Rev B. Removal of Handrail on Terrace. Oct 24

16 St. Peters Road  
Title: Extended Terrace Balustrade & Privacy Screen Details (Sheet 3of5)  
Drawing No: 0122823-Sk39B Scale 1:25,1:10&1:5 @ A3

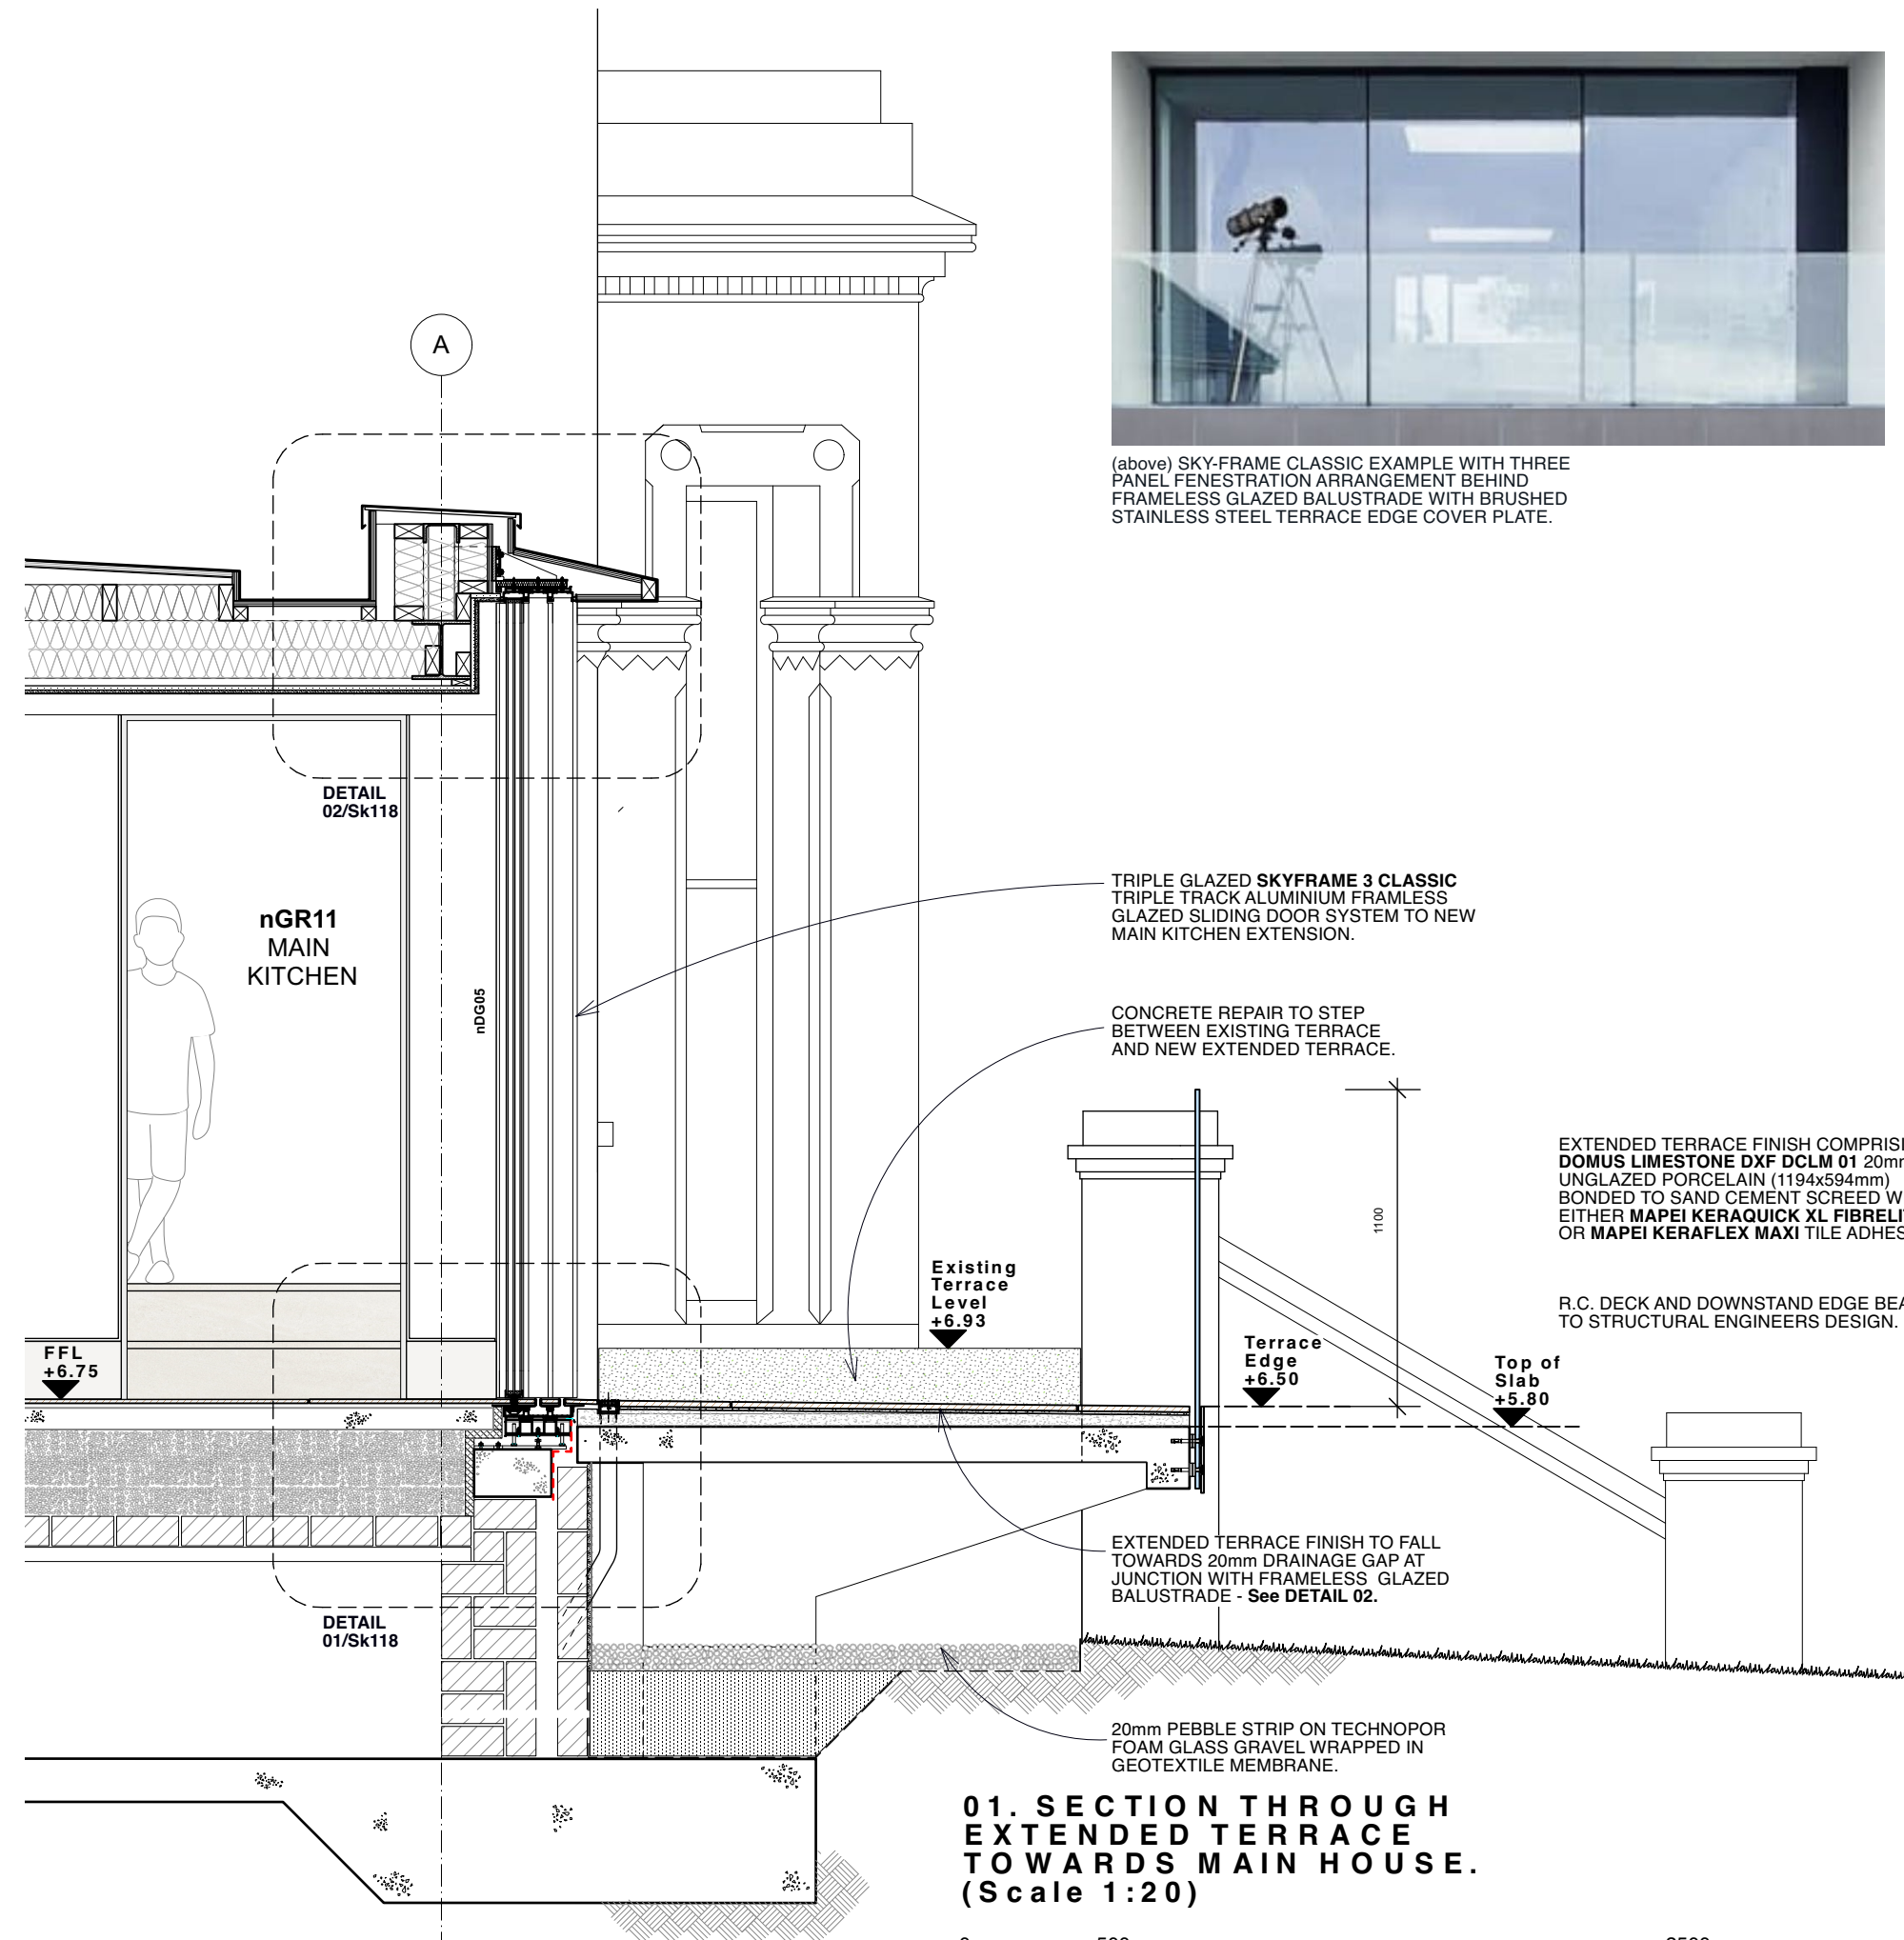
Rev A. Drawing amended following 24/05/24 client comments regarding terrace porcelain tile rail support system. June 24

**02. FRAMELESS GLAZED BALUSTRADE DETAIL. (Scale 1:5)**

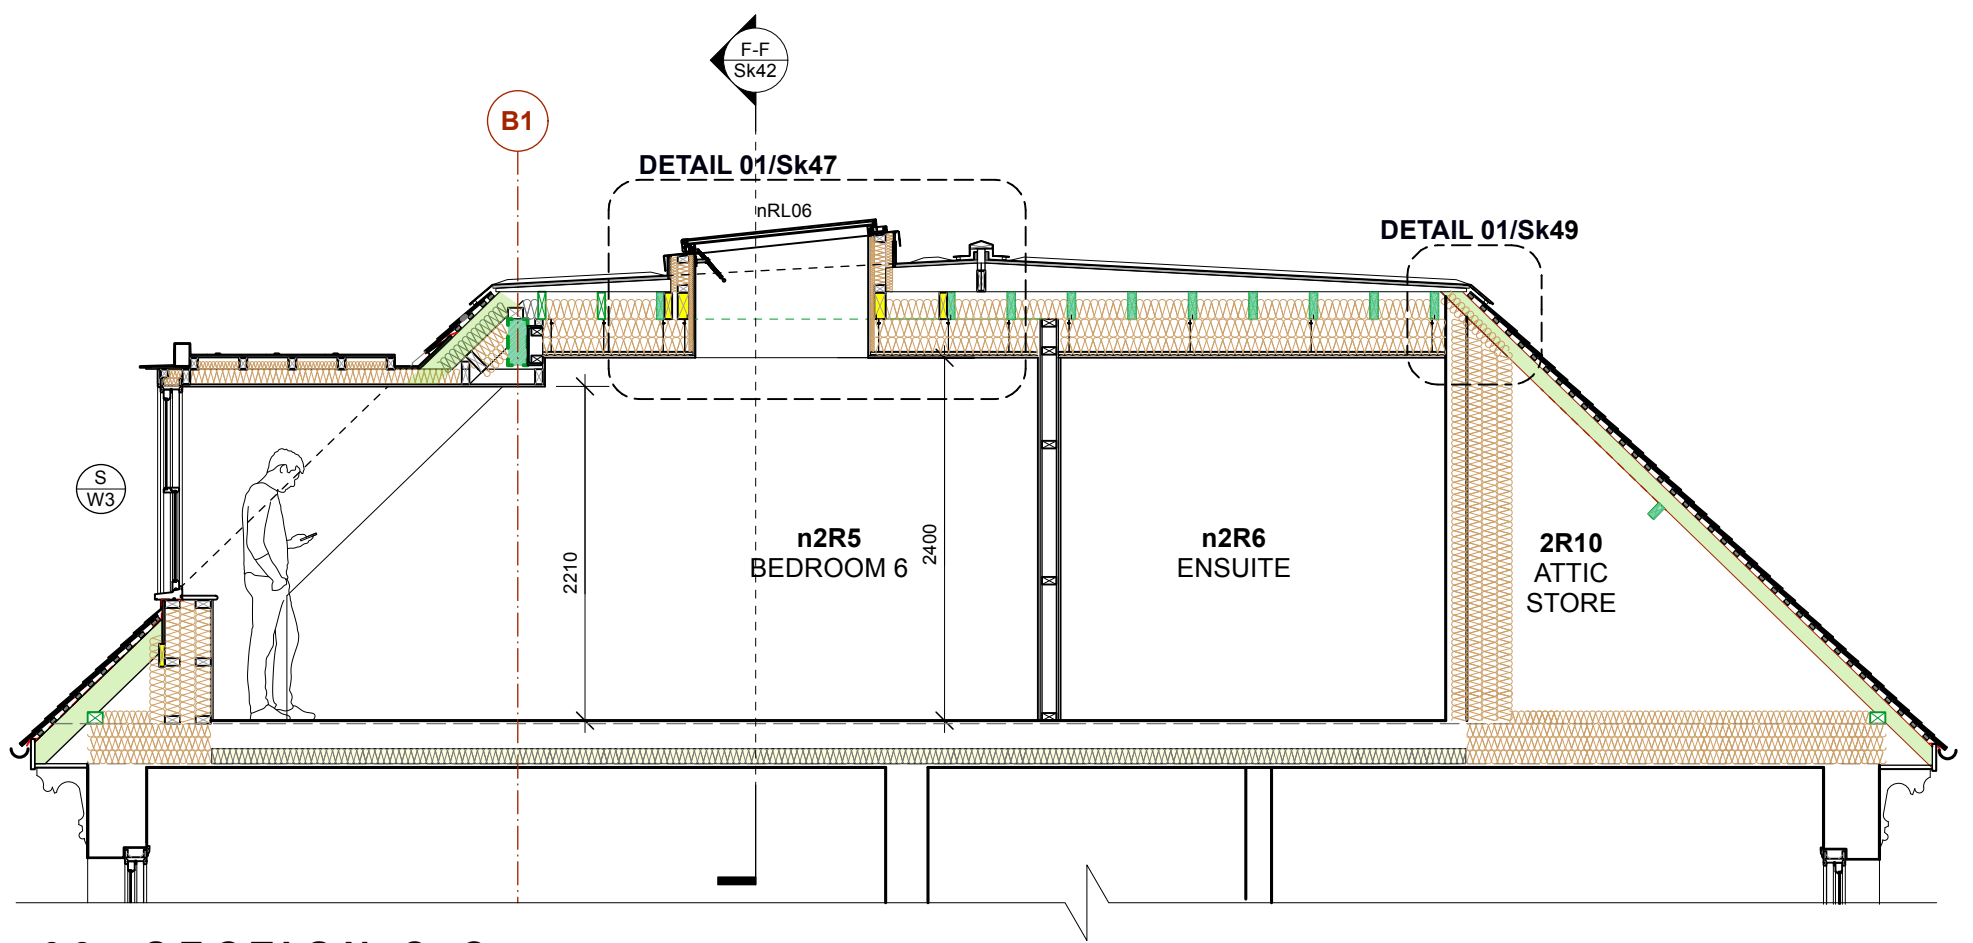
Rev A. Removal of Handrail on Terrace.

### 02. PROPOSED FIRST FLOOR PLAN (Scale NTS)

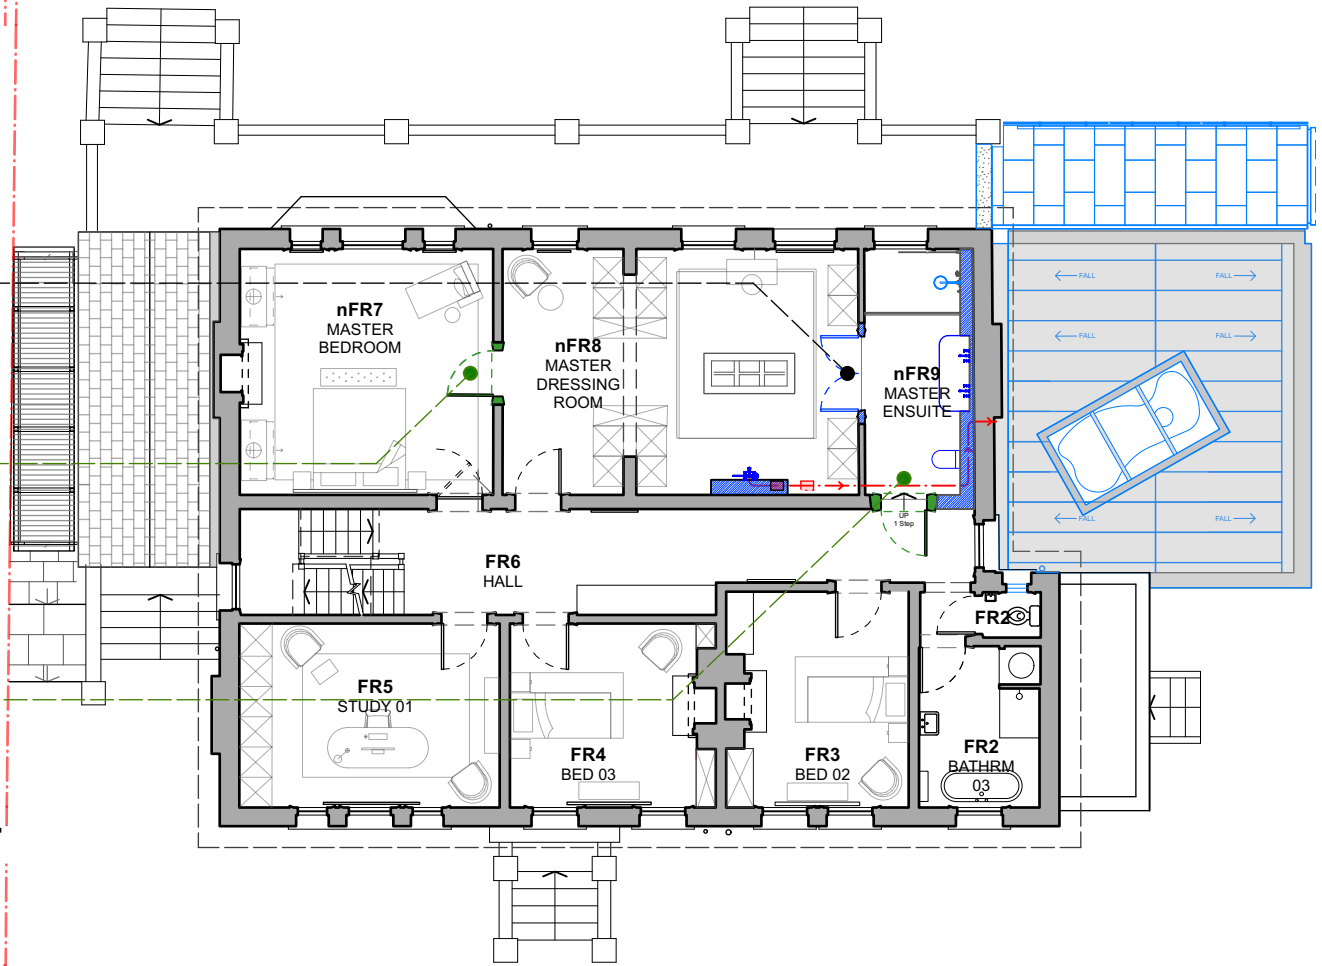
Rev A. Correction to nFD03
